MODEL CL-600-2A12

Service Bulletin No. 601-1114

Revision No. 01 Dated Nov 04/2025

MODIFICATION – NOSEWHEEL STEERING – REPLACEMENT OF POTENTIOMETER UNIVERSAL COUPLING (T16-6) SETSCREWS

Replacement of Universal Coupling (T16-6) Setscrews
Figure 1

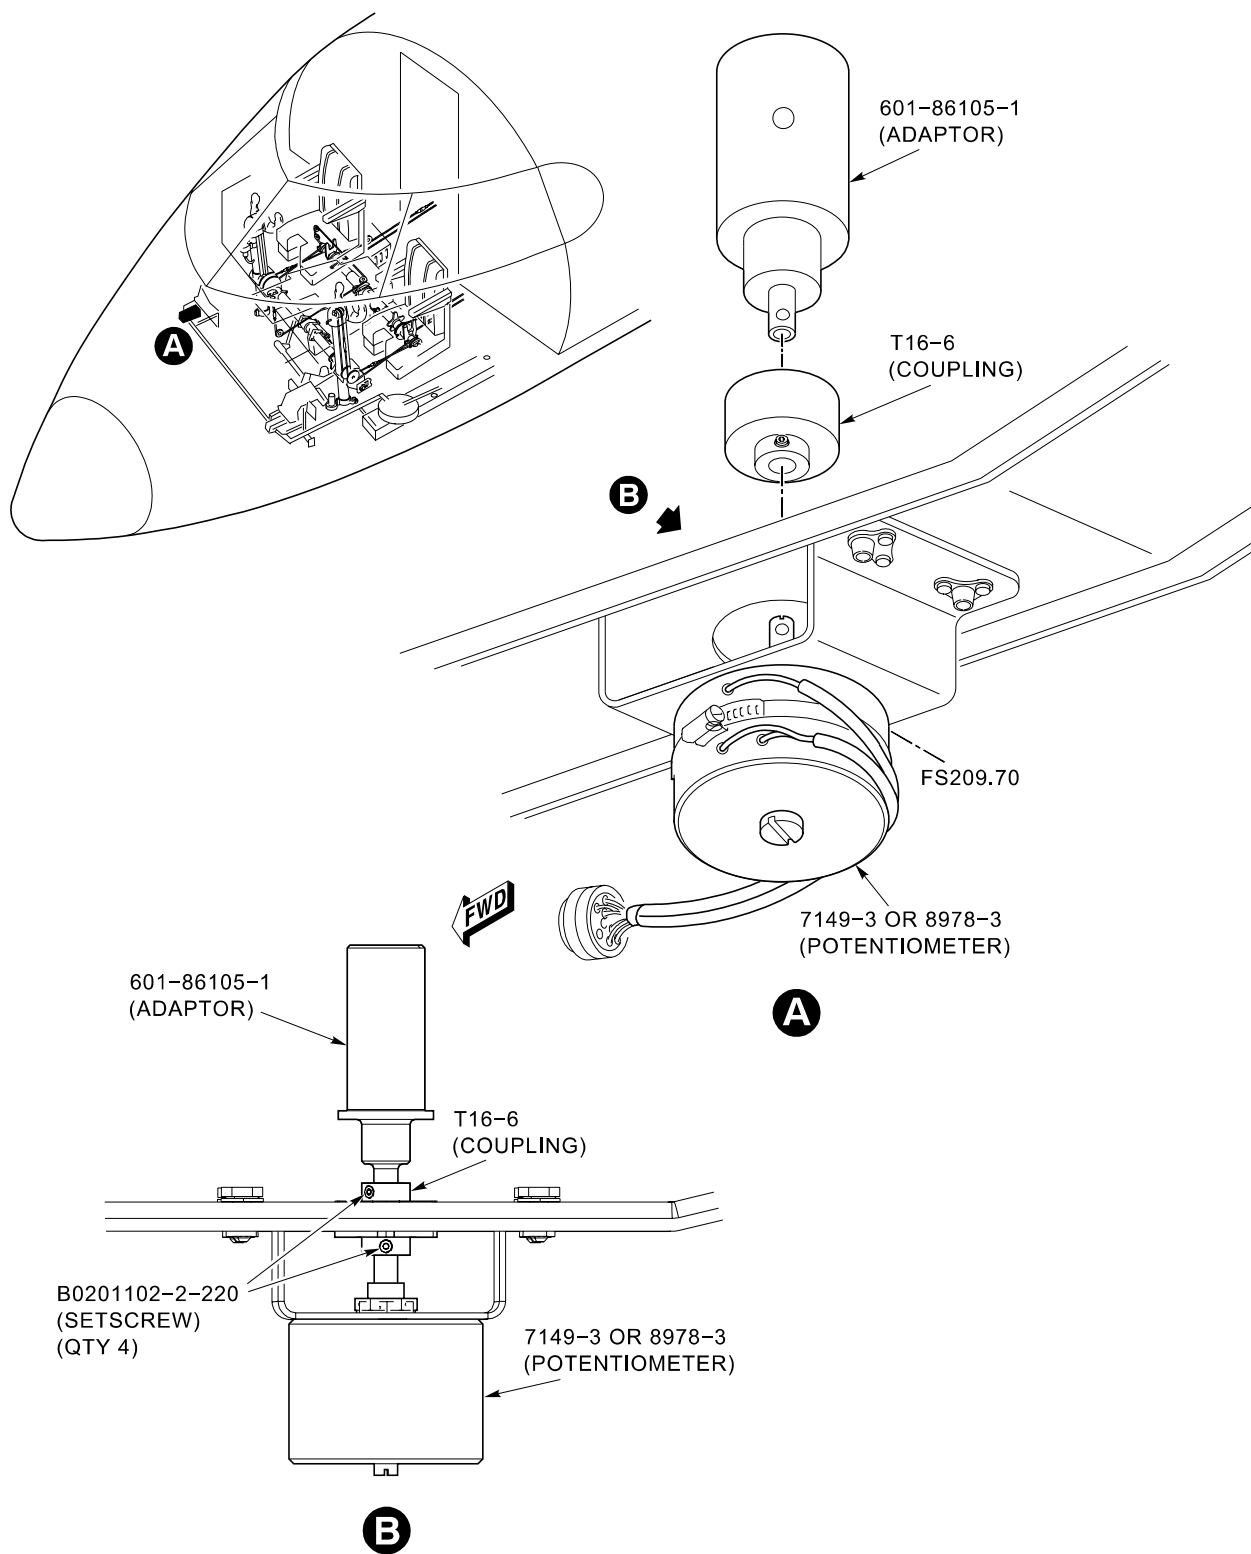
- (1) Get access to potentiometer universal coupling, Part No. T16-6 on rudder feel unit assembly.
- (2) Replace the rudder potentiometer universal coupling as follows:
 - (a) Remove the potentiometer and coupling per AMM 32-50-21 in accordance with AMM Rev 88 and subs, per the applicable procedure (Pre SB 601-1114).
 - (b) Install the new coupling and potentiometer per AMM 32-50-21 in accordance with AMM Rev 88 and subs, including the task instructions related to Post SB 650-32-007 (using new coupler, new type self-locking setscrews, anaerobic retaining compound and specified torque).

(c) Rig the potentiometer per AMM 32-50-21 in accordance with AMM Rev 88 and subs, following task instructions related to Post SB 601-1114.
